Re: Williamsburg Receiving and Storage, LLC
WMD Order No. 31-07-02

Re: Soil and Groundwater Assessment Work Plan
Cherry Blossom, LLC
ISE Project #02061-59E

Re: Initial Technical / Regulatory Review
Preliminary Design and Operation Proposal
Rapid Infiltration Basin System
Cherry Blossom, LLC
ISE Project #02061-57E

PROPOSED INITIAL ASSESSMENT
PARADIS PARCEL

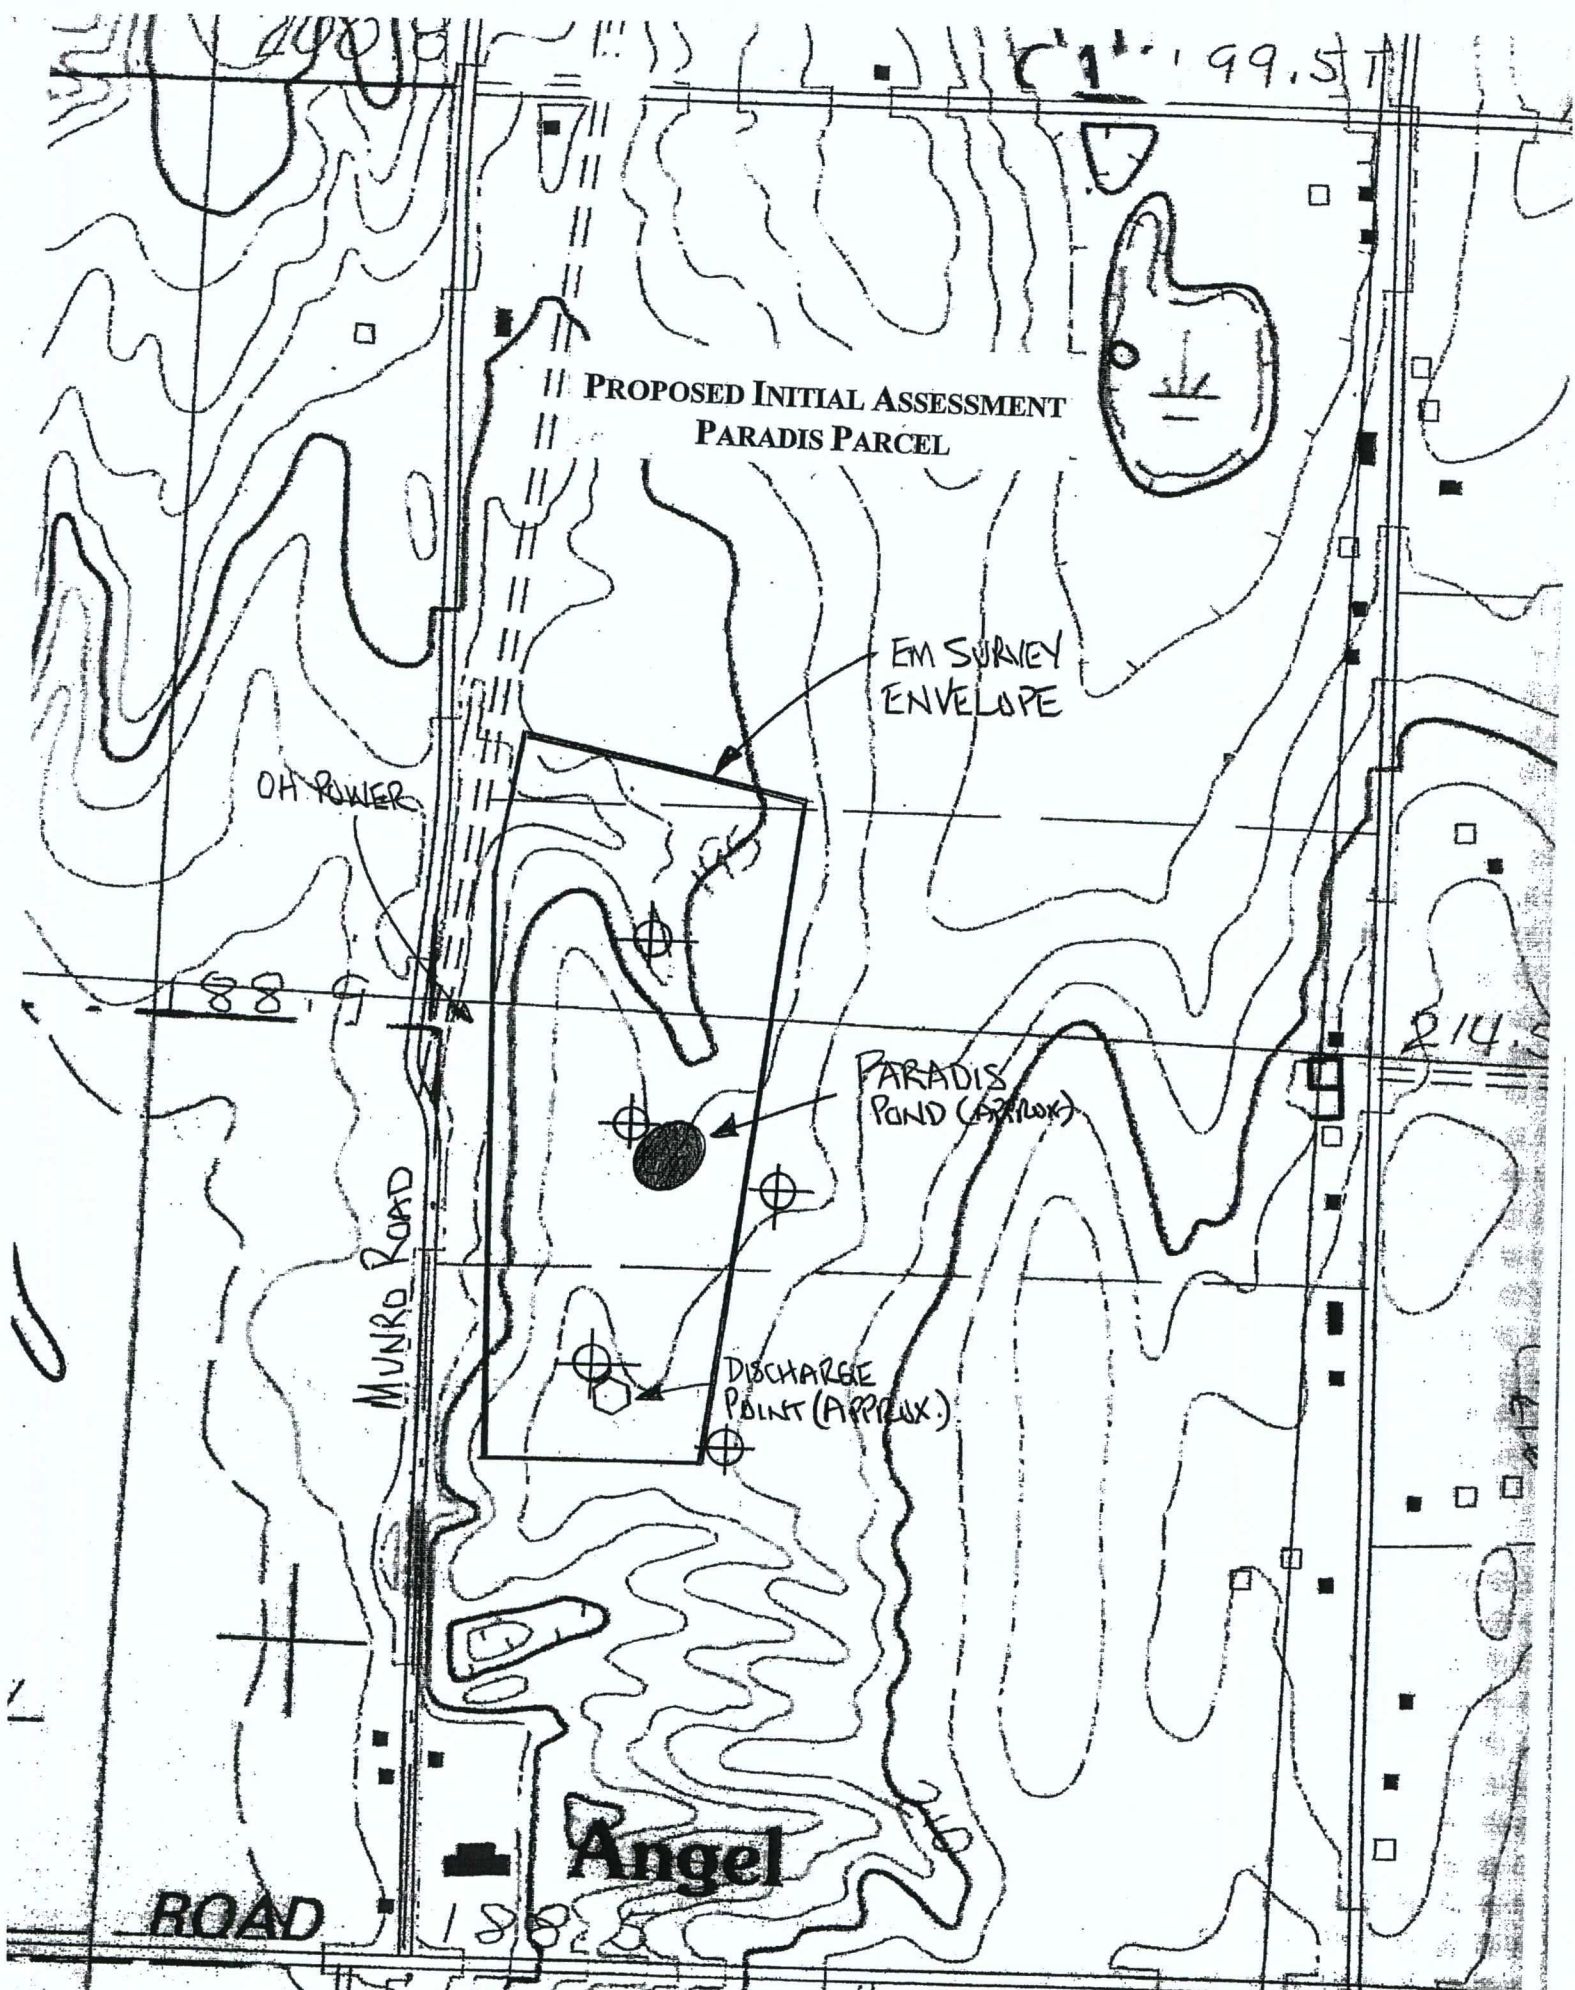
This area presents challenges in assessment due to the non-uniform nature of reported wastewater application. Prior to soil or groundwater sampling, ISE proposes to conduct a frequency-domain electromagnetic (EM) geophysical survey. The EM survey will measure the conductivity of the earth in this area so as to identify areas of maximum and minimum terrain conductivity. This will allow efficient delineation of the probable limits of impact of a conductive wastewater over a wide (elongate) area. Depending upon the EM equipment utilized, an estimate of the depth of impact may also be gained through the same survey.

The EM survey will be followed by shallow soil sampling and analyses that will facilitate a quasi-calibration of the EM results with dissolved solids (chloride principally) content of soil moisture. In the coarse-grained soils present in this area, it is the soil moisture that will give rise to terrain conductivity anomalies. The soil matrix will act largely as an insulator to induced electrical conductance.

Concurrent with evaluation of these data, soil borings and monitoring wells will be installed in the vicinity of the Paradis "pond" and in other areas where MDEQ District Staff notes and distressed vegetation suggest pooling of wastewater may have occurred. It is estimated that five (5) monitoring wells will be installed in conjunction with this initial effort. The purpose of this element of the WP is to gain an initial understanding of gross potentiometric trends and to allow early monitoring of areas where maximum potential for impact exist, while the EM survey is serving to define the limits of further investigation. These five (5) monitoring wells will be installed in areas presumably down-gradient of visually impaired locations with perhaps two (2) of the wells installed topographically higher to provide information on background water quality and potentiometric surface trends. The attached figure shows typical monitoring locations relative to the proposed EM survey area.
